BRUNSWICK STEAM ELECTRIC PLANT, UNIT NOS. 1 AND 2
DOCKET NOS. 50-325 AND 50-324/LICENSE NOS. DPR-71 AND DPR-62
REQUEST FOR EXEMPTION TO 10 CFR 50, APPENDIX R
FIRE PROTECTION PROGRAM FOR NUCLEAR POWER FACILITIES

BRUNSWICK STEAM ELECTRIC PLANT, UNIT NOS. 1 AND 2
NRC DOCKET NOS. 50-325 AND 50-324
OPERATING LICENSE NOS. DPR-71 AND DPR-62
REQUEST FOR EXEMPTION TO 10 CFR 50, APPENDIX R
FIRE PROTECTION PROGRAM FOR NUCLEAR POWER FACILITIES

BASIS FOR EXEMPTION REQUEST

TYPICAL FIRE BREAK DESIGN
ELEVATION 50' - EAST

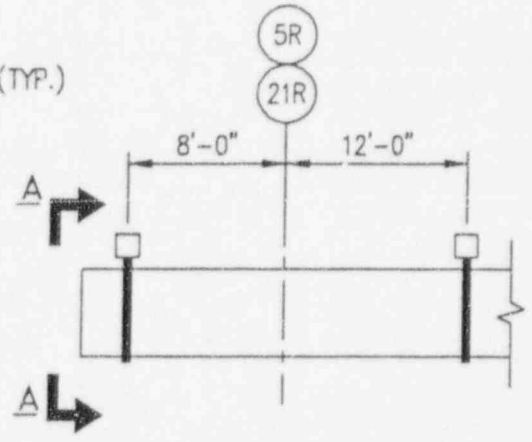
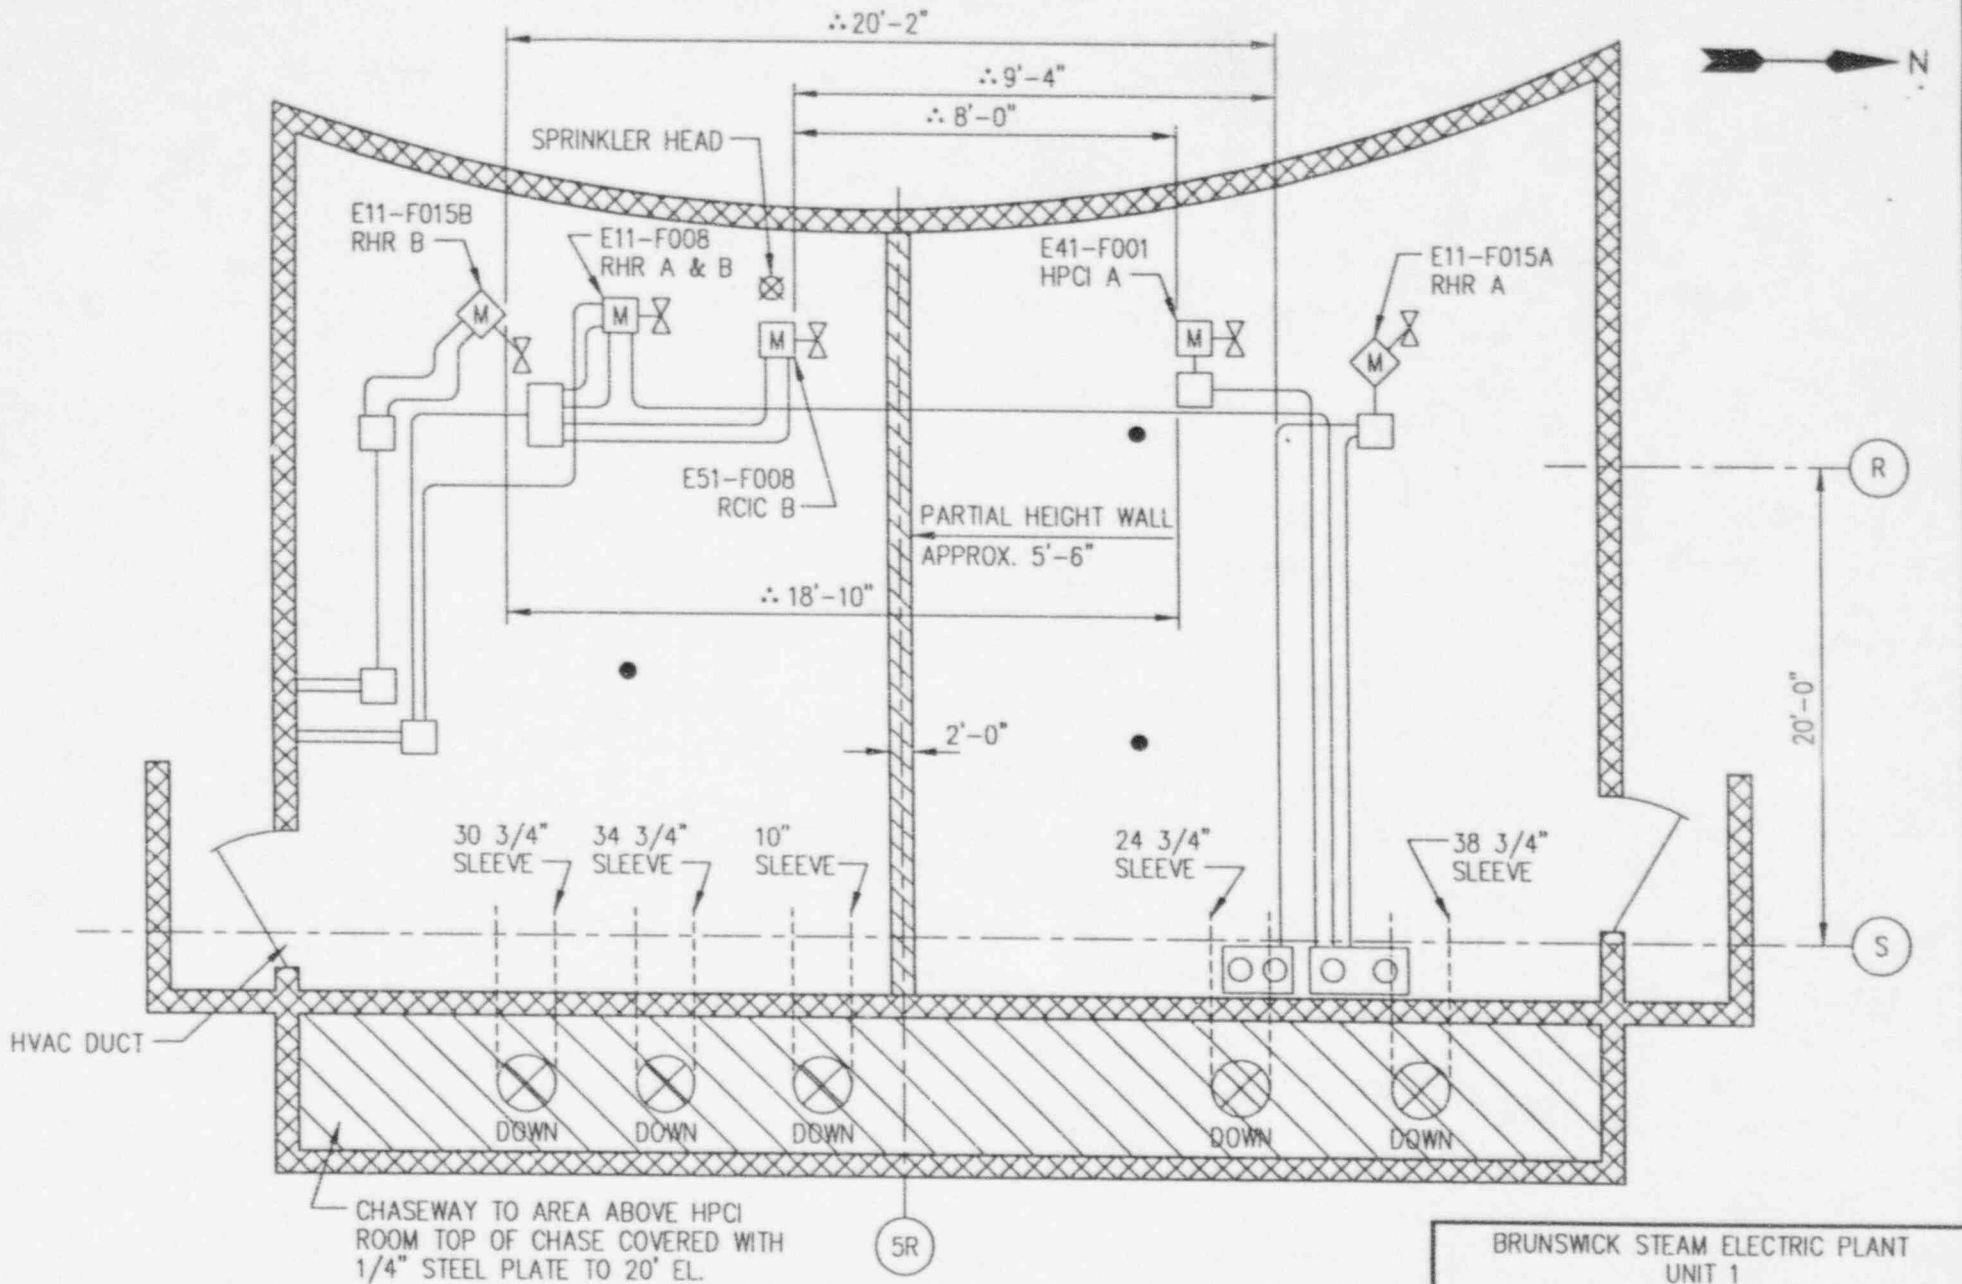
The cable trays are currently wrapped with Thermo-Lag material. Based on the NRC's concern identified in Information Notice 95-27, CP&L proposes to remove the Thermo-Lag material and replace it with fire stops at the north and south ends of the separation zone similar to the design used in the Southwest corner of the Unit 1 Reactor Building Separation Zone. The typical configuration of the proposed fire stop design is shown in Attachment A. The combination of the administrative controls, closely spaced sprinklers acting as a water curtain, fire detection system, smoke draft stops and the addition of these cable tray fire stops provides assurance that a single fire will not adversely impact the ability to achieve and maintain safe shutdown.

NOTE:
TWO FIRE BREAKS PER UNIT - ONE AT EACH END OF 20' SEPARATION ZONE.

1" MARINITE BOARD FASTENED TO STEEL SUPPORTS

BRUNSWICK STEAM ELECTRIC PLANT UNIT 1 CAROLINA POWER & LIGHT COMPANY
FIRE AREAS RB1-6 SAFE SHUTDOWN RACEWAYS AND EQUIPMENT (N.T.S.)
ATTACHMENT B

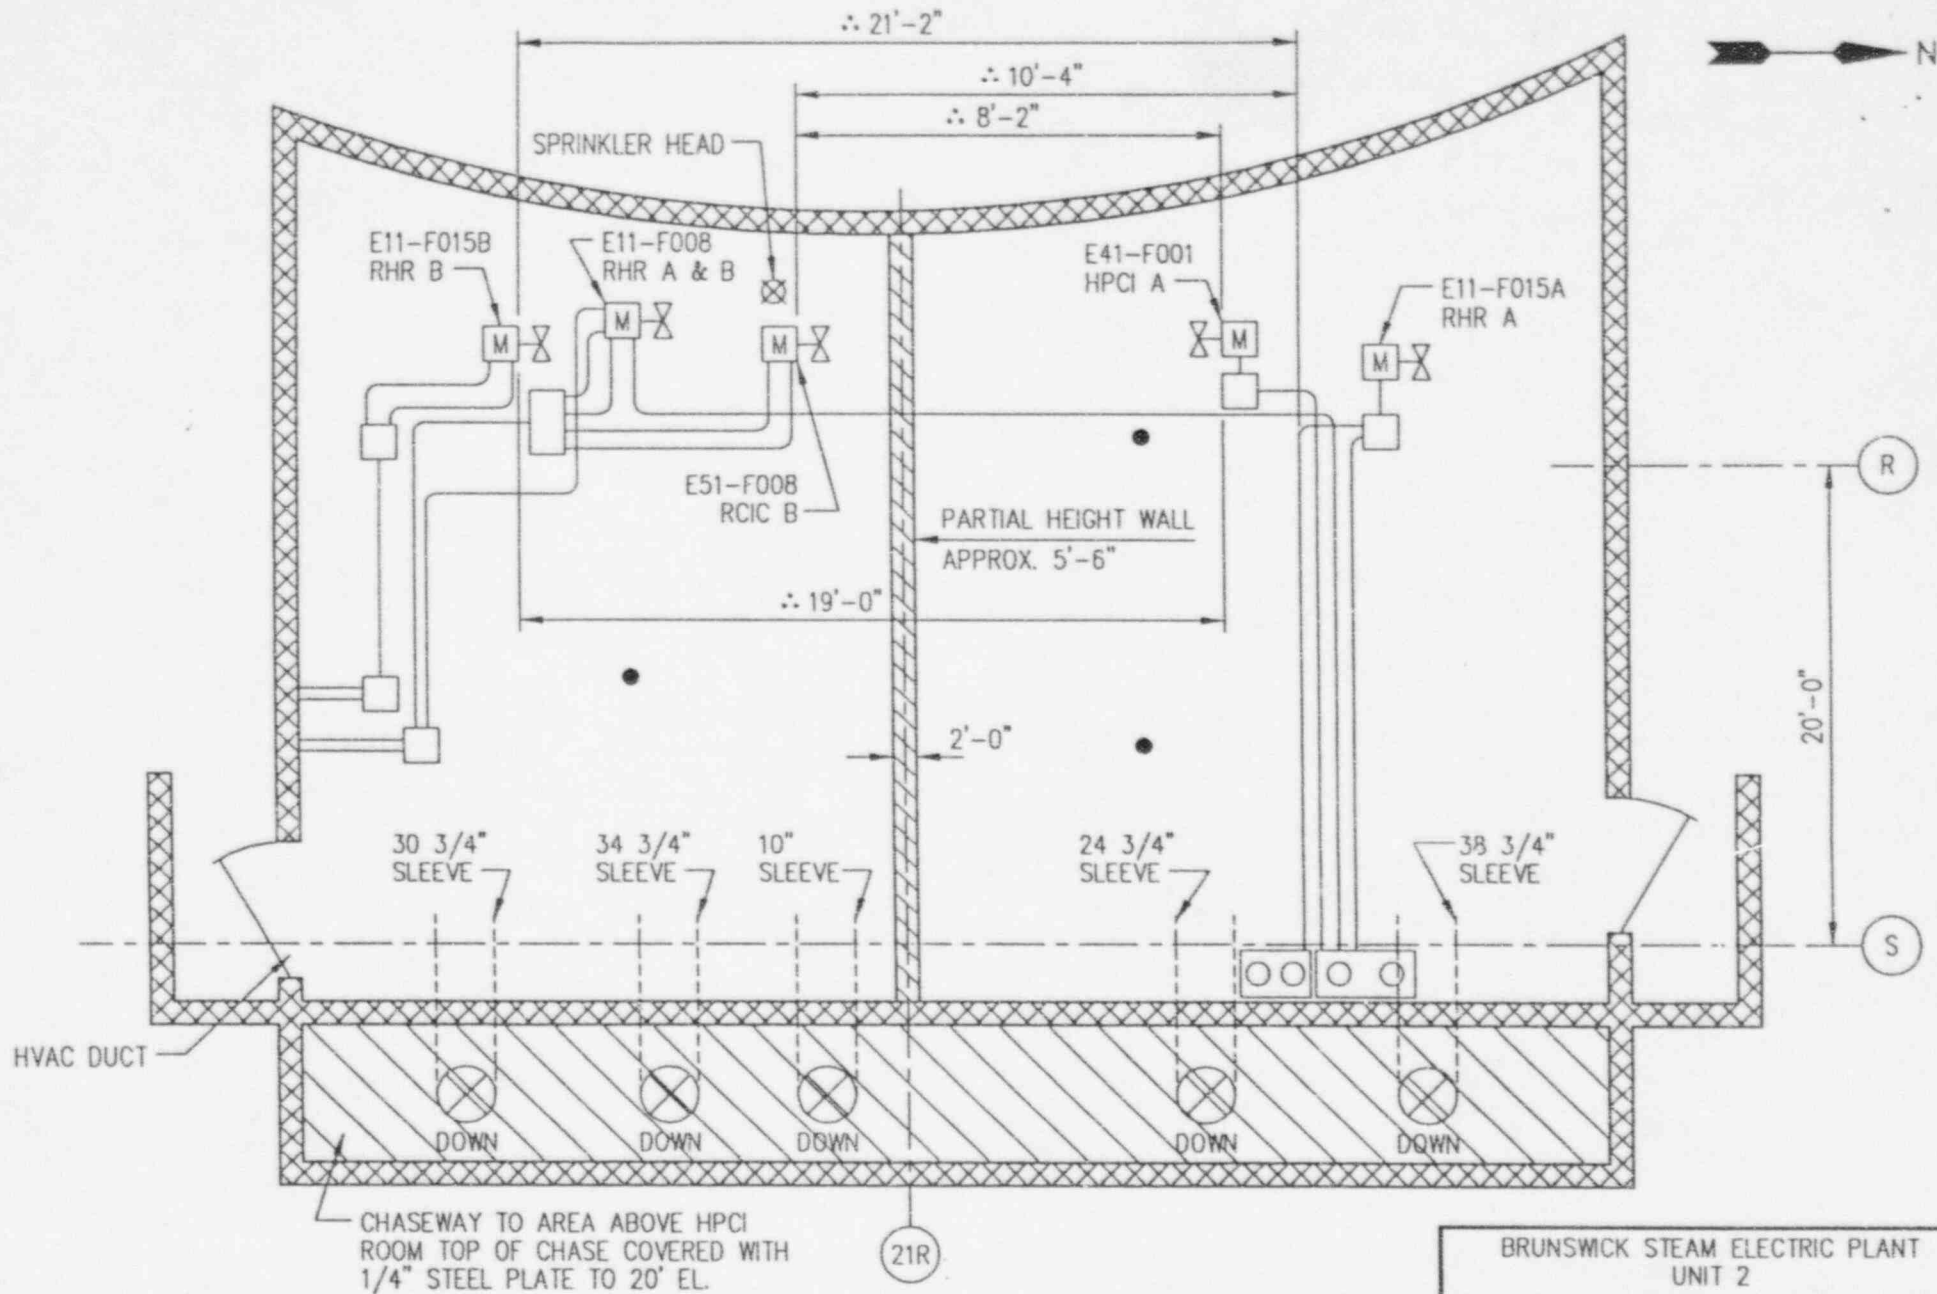
CP&L proposes the use of Low Pressure Coolant Injection and safety/relief valves as a redundant safe shutdown system. The new redundant shutdown equipment components for the reactor pressure level control function for a fire in this area consist of electrical cables and motor-operated valves for the RHR injection inboard isolation Train A and B valves (E11-F015A and E11-F015B). Attachments B and C identify the location of the HPCI, RCIC and RHR isolation valves. The Train A and Train B RHR injection valves and cables are greater than 20 feet apart and are located between 9 to 19 feet from their redundant HPCI or RCIC isolation valve. A partial height concrete wall (approximately 5 ½ feet tall) is also located between these components and a fast response automatic sprinkler head is located adjacent to the RCIC steam outboard isolation valve. This fire area is also provided with a fire detection system.

The original exemption identified cable protection for the RCIC valve (E51-F008) and the RHR Shutdown Cooling valve (E11-F008) to ensure availability of these components in the event of a fire on the north side of the partial height wall. CP&L proposes to use the Low Pressure Coolant Injection System, if fire damage occurs to the RCIC or HPCI components and cables instead of fire wrap protection for these circuits. As stated above the separation between the LPCI valves and cables is greater than 20 feet with low fixed combustible loading in the area, partial height concrete wall, limited accessibility into the area during operation (locked fire door), area fire detection system, and a fast response automatic sprinkler head adjacent to the RCIC valve which provides suppression between the redundant safe shutdown components. Attachments B and C show the arrangement of the equipment located in the ECCS rooms (RB1-6 and RB2-6) and the distances between the components. The RHR Shutdown Cooling valve (E11-F008) is normally closed and is not required post-fire until shutdown cooling is necessary. CP&L will perform a manual operation of this valve if fire damage to the associated cabling results in a loss of the normal valve controls. Emergency lighting will be provided by means of portable lighting since this action is not required for hot shutdown.
